# United States Department of the Interior

### MEMORANDUM

**Subject:** Inspection of fishways at Holtwood Hydroelectric Project (FERC #1881)

### **Tailrace bathymetry:**

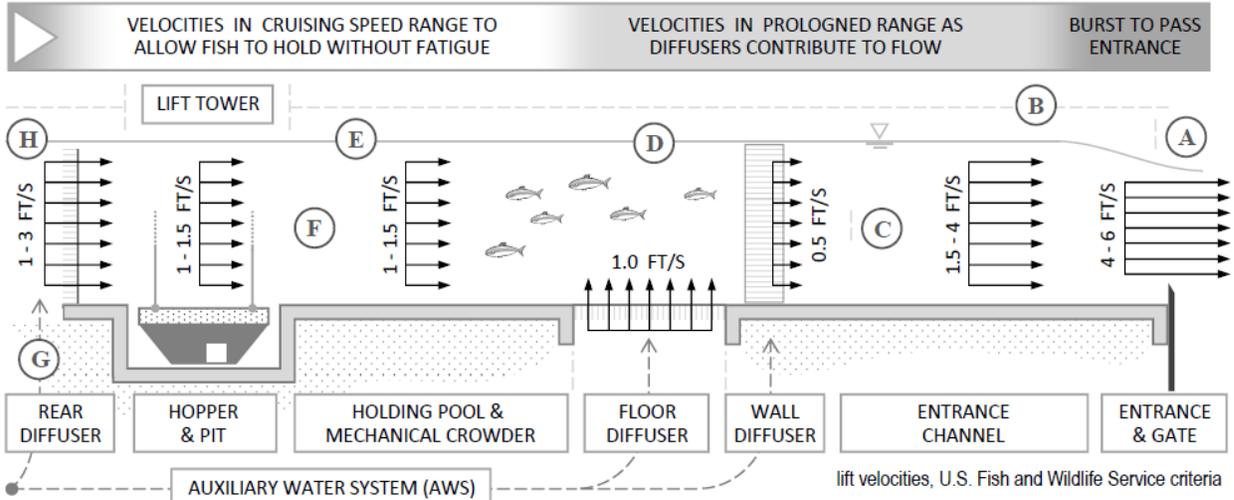
- High velocity barriers - After extensive stream work in the tailrace to provide target migratory fish with a continuous and accessible low velocity zone of passage all the way into the fishway, the Licensee and its consultants have identified that undesired high velocity areas still remain. The Licensee informed the Service that they intend to go back into the tailrace sometime in the next year, prior to the 2016 migration season, to work on these and confirm that hydraulic conditions within the Project are adequate for the safe and timely passage of all target migratory species.
